# CITY OF BETHLEHEM

RE: (21-011 LD&S) – 21080004 – 14-36 W. 3<sup>rd</sup> Street– Land Development and Lot Consolidation Plan – Ward 2, Zoned CB, plan dated August 9, 2021 and revised on November 5, 2021.

The above-referenced plan has been reviewed by the appropriate City offices. We offer the following comments:

**1st Floor**  
SCALE: 1/16" = 1'-0"

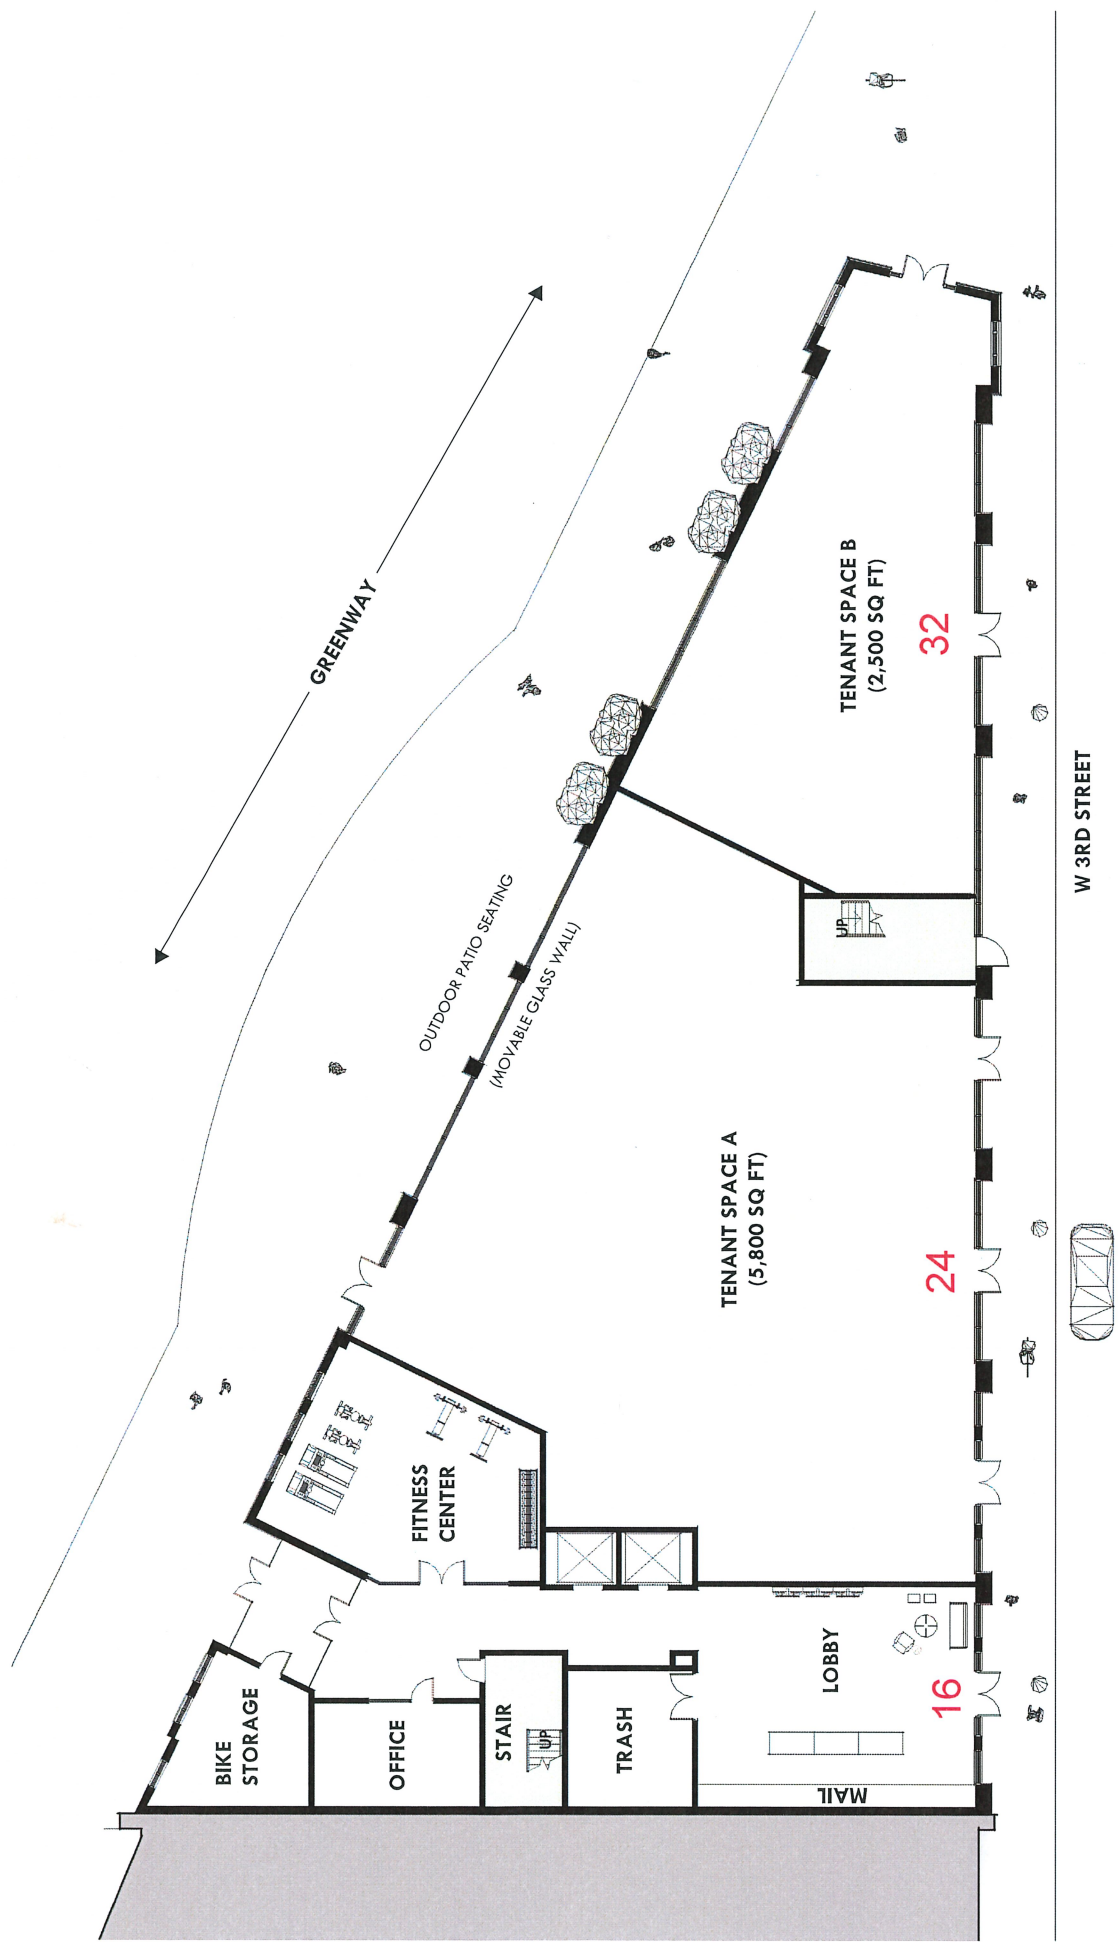
4. Since there will be separate entrances for each use, the addresses shall be as follows.
  - a. 16 W 3<sup>rd</sup> St – Apartments (See attached for apartment numbering plan)

- b. 24 W 3<sup>rd</sup> St – Tenant Space A
  - c. 32 W 3<sup>rd</sup> St – Tenant Space B
5. An engineer's opinion of probable cost shall be submitted for review by the City's Engineering Bureau and for use in preparing the Developer's Agreement.
